L-1: Proposed Site Plan

E-1: Existing Conditions Plan

THE SULLIVAN RESIDENCE

22 BUCKMASTER DR.
Sudbury, Massachusetts

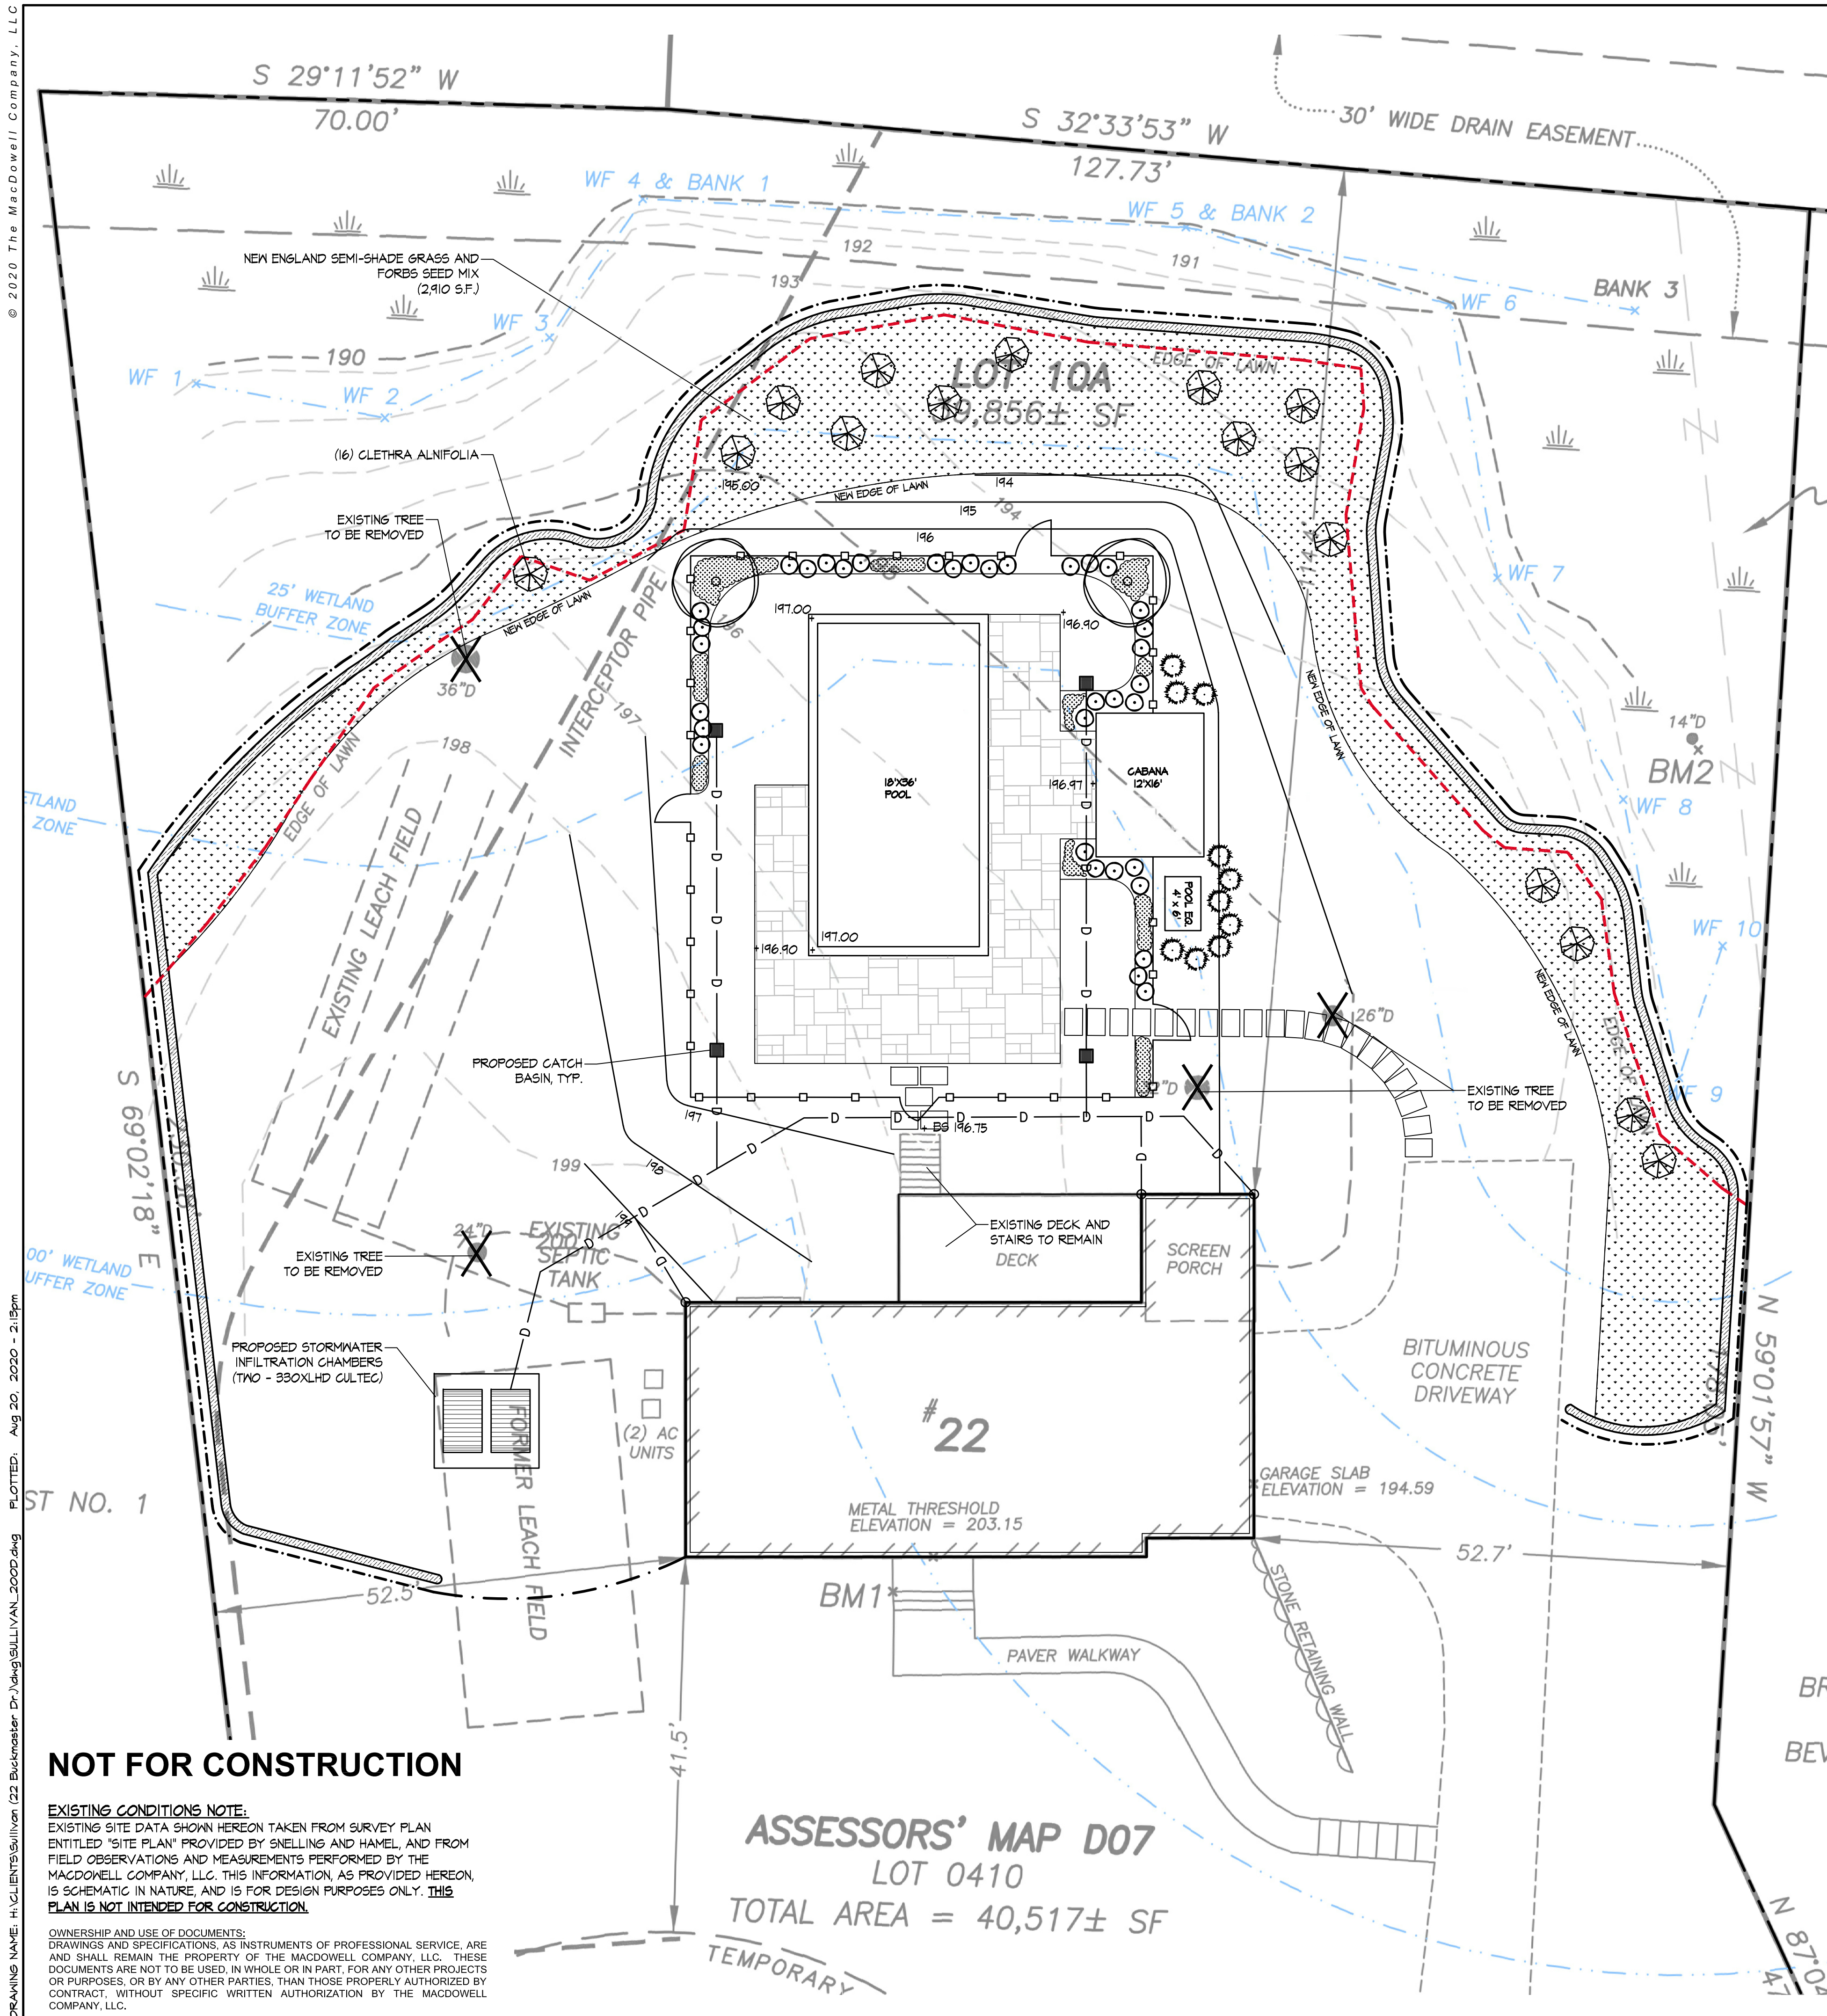
- Proposed plan illustrating reduced pool size, from 20x40 to 18x36.
- Reduction of pool terrace by 572 square feet
- Pergola is no longer part of the project.
- Proposed pool fence has been reduced by 17 linear feet.
- Mitigation area (seed mix and proposed shrubs) is 2,910 s.f., which provides a 1.5 : 1 ratio.
- Providing 16 shrubs in mitigation area, which is 4 shrubs for each tree being removed.
- Wetland mitigation calculations that compare the previous January 21, 2020 plan with our current plan.
- Plant list with native / noninvasive plant species
- Notes referencing the removal of invasive species
- Note stating that the mitigation area will be delineated by a 4" square, 12" height green marker. Precedent image is included.
- Cut sheets of drainage material as well as proposed grading and drainage information located on the plan
